Pre-bid Meeting – BEML Response to Pre-bid Queries from Bidders - Set 3

**Name of the Work:** Engineering, Procurement & Construction pertaining to establishment of Rail coach factory including Civil Construction of manufacturing blocks, testing bay, other utility buildings (Non factory buildings), Railway Track sidings, water supply and distribution System, Roads, Drainage and sewerage systems, General Electric works including regular and emergency power supply and distribution system, related installations & services ( Fire, Gas, Compressed air, IT, BMS, etc.), MFA (Miscellaneous fixed assets) and other Land & Site development works including grading, levelling works in connection with setting up of a Rail Coach Factory hereinafter referred as BEML RAIL HUB FOR ADVANCE MANUFACTURING (BRAHMA) near Umaria village, Obaidullaganj, District- Raisen, Madhya Pradesh (India) on EPC Mode.

**Tender Notice No. :**6300040573 dated 25.05.2026

CENTRALISED COMPRESSED  
AIR STATION

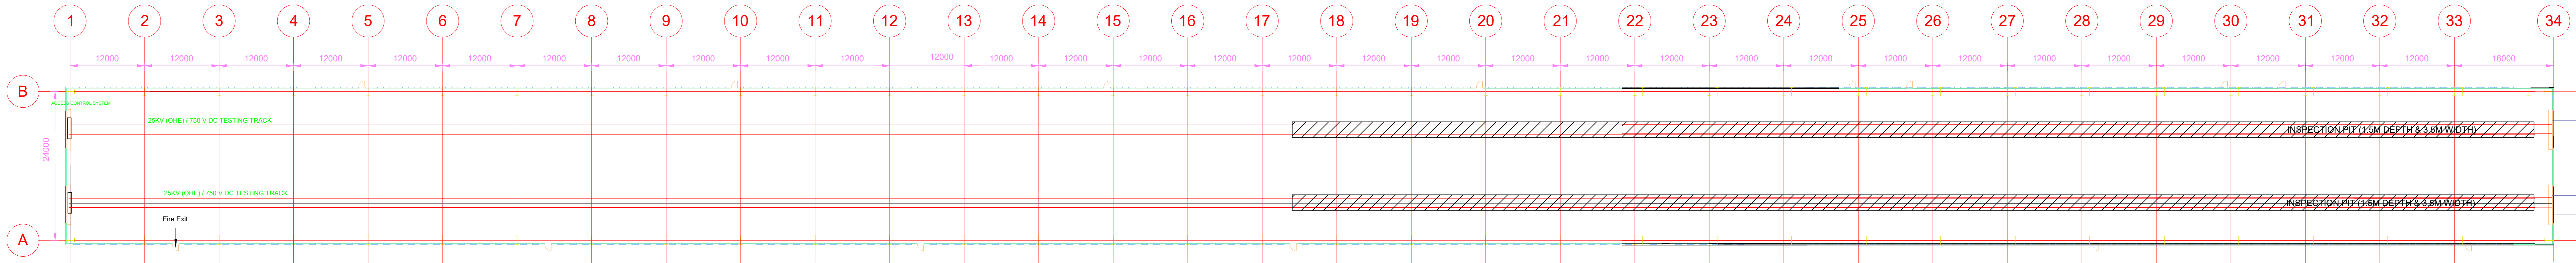
| Sl. No. | RFP Clause Ref. and Page No.                                                                                                                         | Content of RFP requiring Clarification                                   | Bidder Queries                                                                                                                                                                                                                                                                                                                                                                                         | Response/ Clarification by Customer                                                                                                                                                                |
|---------|------------------------------------------------------------------------------------------------------------------------------------------------------|--------------------------------------------------------------------------|--------------------------------------------------------------------------------------------------------------------------------------------------------------------------------------------------------------------------------------------------------------------------------------------------------------------------------------------------------------------------------------------------------|----------------------------------------------------------------------------------------------------------------------------------------------------------------------------------------------------|
| 33      | 1. Corrigendum-3 Merged Documents (CENTRALISED COMPRESSED AIR STATION) Plan<br>2. Corrigendum-3 Merged Documents (Facilities-wise Material schedule) | Centralised Compressed Air Station outer wall                            | As per Corrigendum-3, Centralised Compressed Air Station floor plan the height of wall is mentioned as 2.4m. However, the corrigendum-3 Merged Documents (Facilities-wise Material Schedule), AAC block masonry is specified only up to 3m from FFL, and the remaining height is to be constructed using galvalume sheets. Kindly confirm the height of outer wall of Compressed air station building. | Follow corrigendum-3                                                                                                                                                                               |

| Sl. No. | RFP Clause Ref. and Page No.                                                                                     | Content of RFP requiring Clarification                                                                      | Bidder Queries                                                                                                                                                                                                                                                                                                                                                                                | Response/ Clarification by Customer                                                                                                                                                                                                                                                                            |
|---------|------------------------------------------------------------------------------------------------------------------|-------------------------------------------------------------------------------------------------------------|-----------------------------------------------------------------------------------------------------------------------------------------------------------------------------------------------------------------------------------------------------------------------------------------------------------------------------------------------------------------------------------------------|----------------------------------------------------------------------------------------------------------------------------------------------------------------------------------------------------------------------------------------------------------------------------------------------------------------|
| 68      | General PB reply set 1 point no 330 & MEC-I0047-01-48-D1-XX-15-DR-A-01100 R2.0 received along with Corrigendum-3 | No underslung crane is required for compressor room.                                                        | Underslung crane of capacity 5T shown in revised drawing. Hence mismatch with PB reply & drawing.                                                                                                                                                                                                                                                                                             | Revised drawing is enclosed with correction.                                                                                                                                                                                                                                                                   |

The above referred PDF drawing of compressed air station has been withdrawn and the revised Compressed Air Station in PDF has been enclosed in this Corrigendum.

| MASTER PLAN LAYOUT                                                                                               |                 |

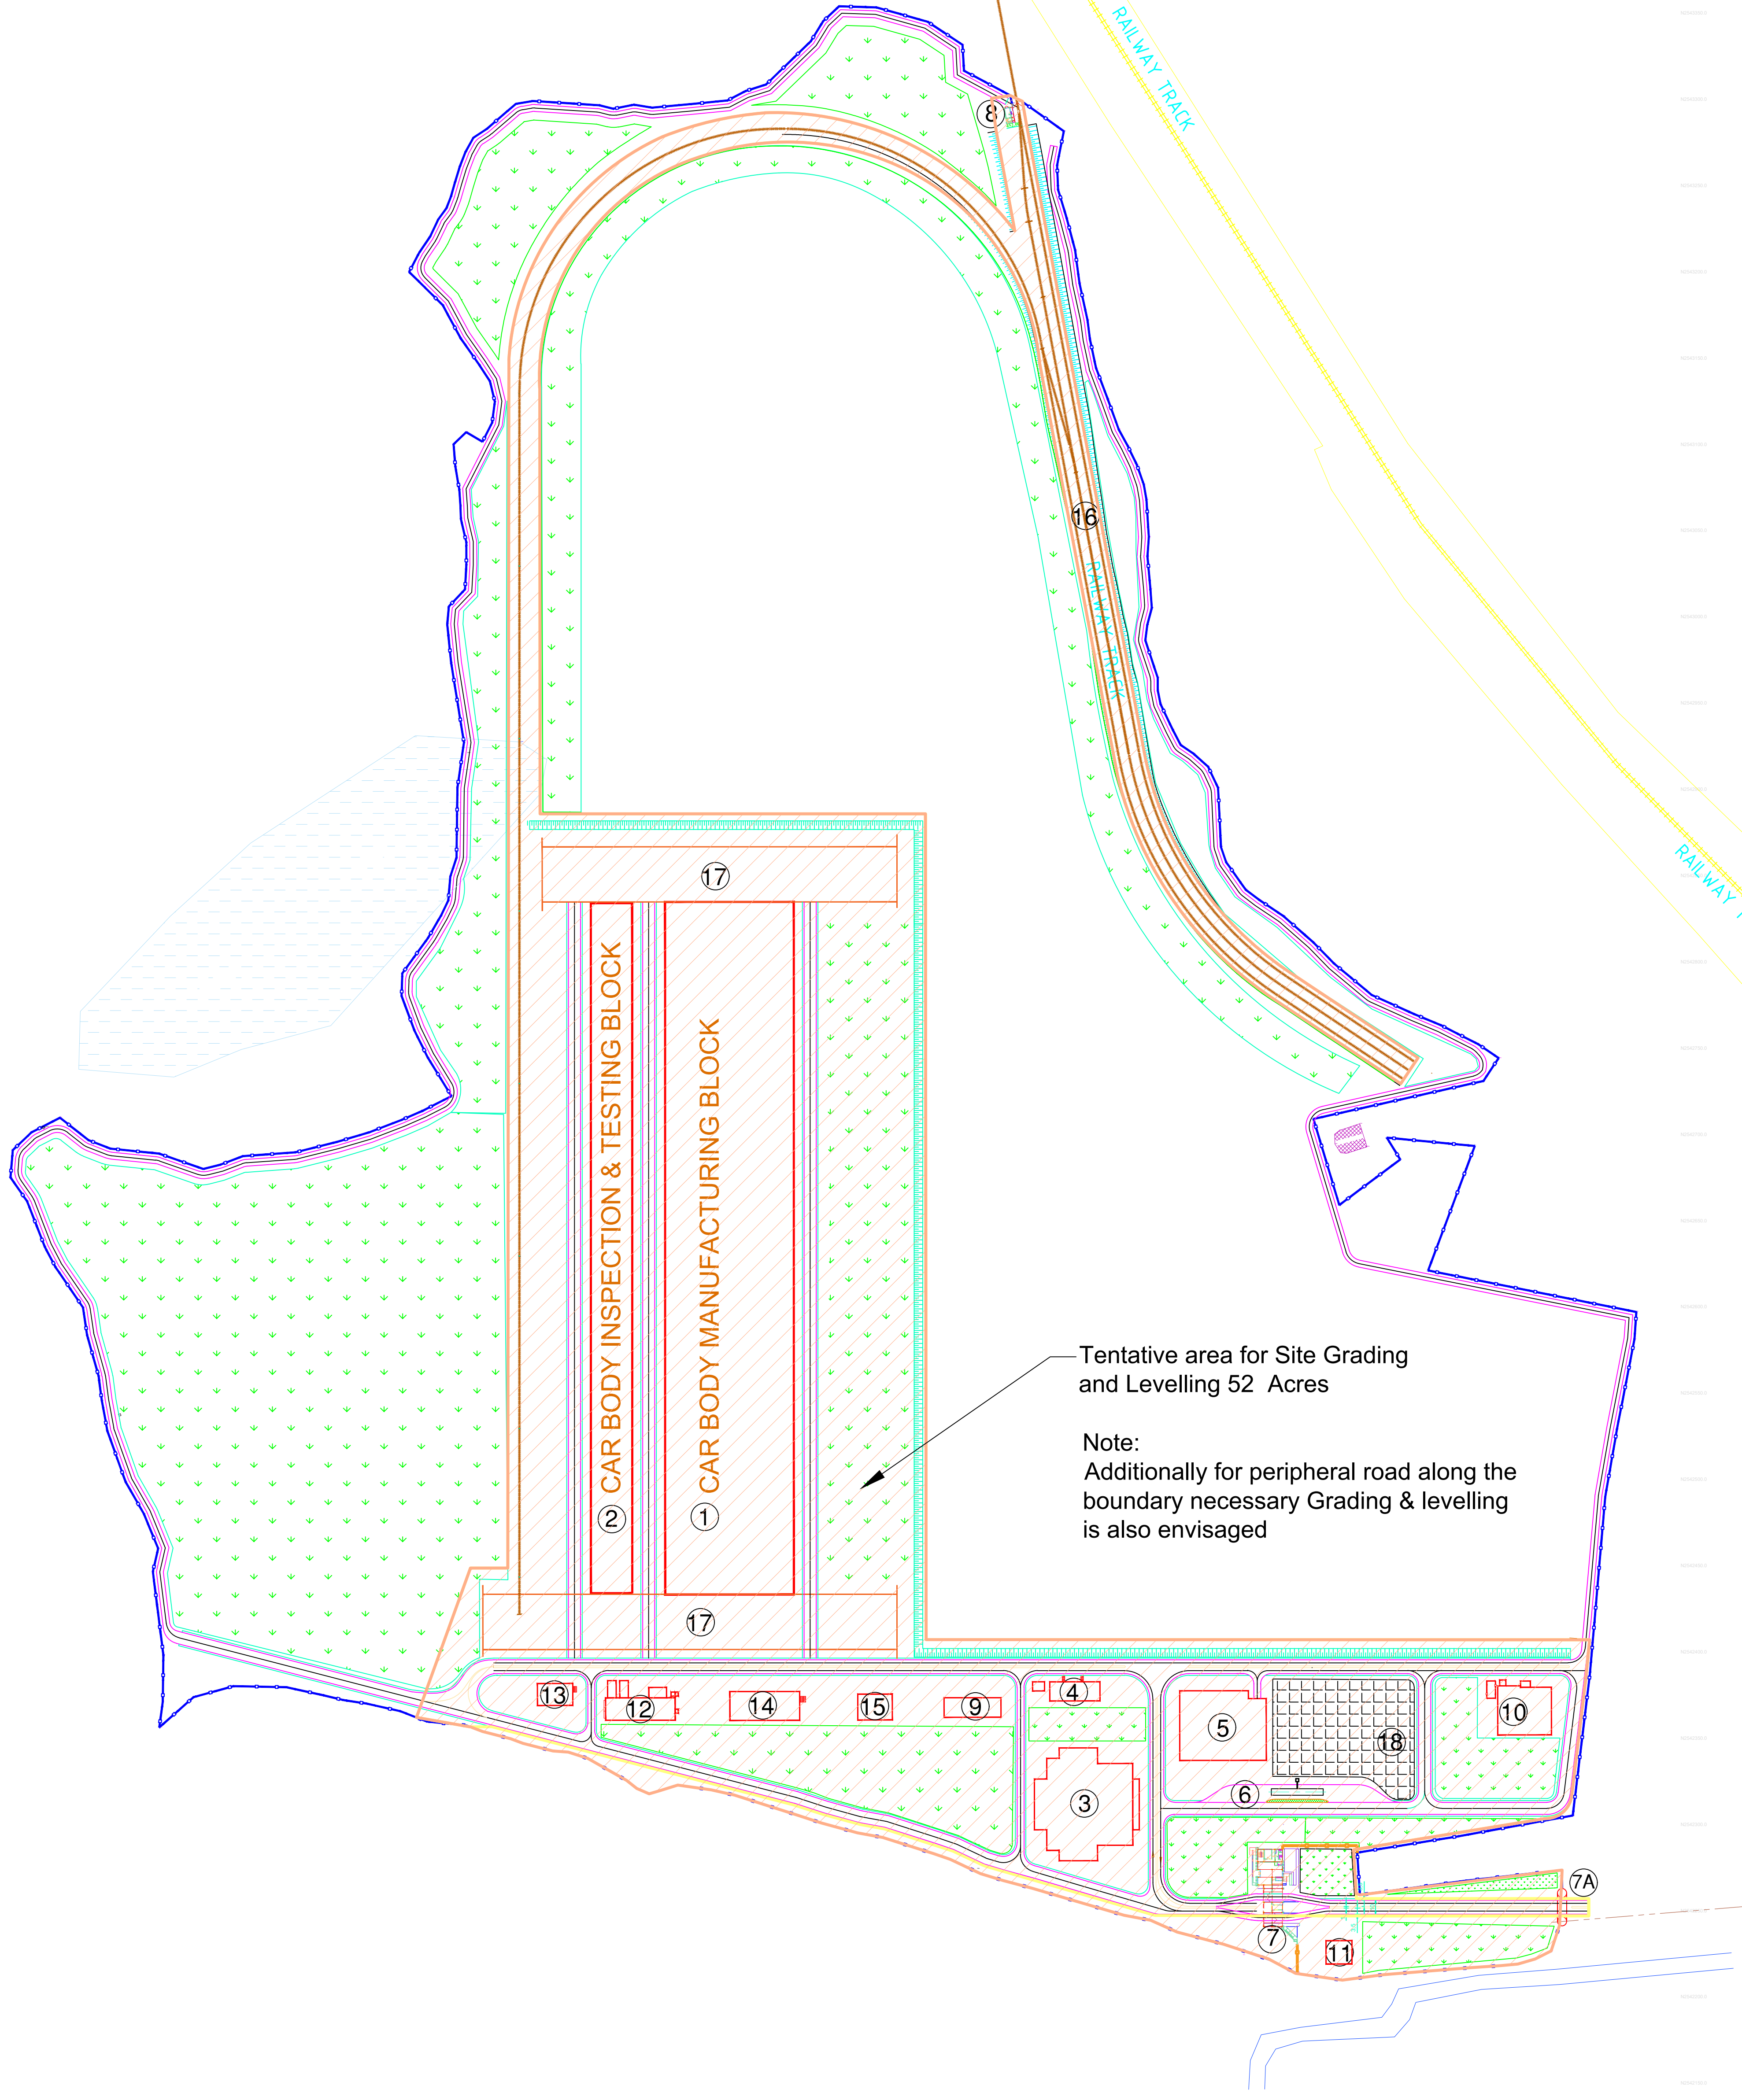
| Sl. No. | RFP Clause Ref. and Page No.                                                                                                                                   | Content of RFP requiring Clarification                    | Bidder Queries                                                                                                                                                                                                                                       | Response/ Clarification by Customer                                                                                                                                                                                                               |
|---------|----------------------------------------------------------------------------------------------------------------------------------------------------------------|-----------------------------------------------------------|------------------------------------------------------------------------------------------------------------------------------------------------------------------------------------------------------------------------------------------------------|---------------------------------------------------------------------------------------------------------------------------------------------------------------------------------------------------------------------------------------------------|
| 8       | Documents-<br>Corrigendum-1 Pre-bid Queries – BEML Response to Pre-bid Queries from Bidders (Set - 1)<br>Sr. no. 103                                           | Boundary Wall inside plant is in the scope of EPC tender. | We presume that internal boundary wall will be only limited to area around Main Gate Complex.                                                                                                                                                        | Yes, to regulate the entry & exit only through main gate entrance & exit, the gaps between gate complex and nearest boundary existing boundary wall are to be closed by constructing boundary wall which is shown in revised master layout (R-02) |

| Sl. No. | RFP Clause Ref. and Page No.                                                                                                                         | Content of RFP requiring Clarification                                   | Bidder Queries                                                                                                                                                                                                                                                                                                                                                                                         | Response/ Clarification by Customer                                                                                                                                                                |
|---------|------------------------------------------------------------------------------------------------------------------------------------------------------|--------------------------------------------------------------------------|--------------------------------------------------------------------------------------------------------------------------------------------------------------------------------------------------------------------------------------------------------------------------------------------------------------------------------------------------------------------------------------------------------|----------------------------------------------------------------------------------------------------------------------------------------------------------------------------------------------------|
| 37      | Corrigendum-3 Merged Documents Pg.no 61                                                                                                              | Structure at 7A in master plan                                           | Kindly provide the details of facility 7A shown in master plan and clarify if any structure that is needed at 7A except a Sliding Gate                                                                                                                                                                                                                                                                 | Gate shall have two segments one for incoming and another for outgoing. Each segments will have two leaf gate of size 6m (W) x 3m (H). No structure other than the gate itself is envisaged at 7A. |

The above referred drawing of Master Layout has been withdrawn and the Master Layout in both PDF and AutoCAD format has been enclosed in this Corrigendum.
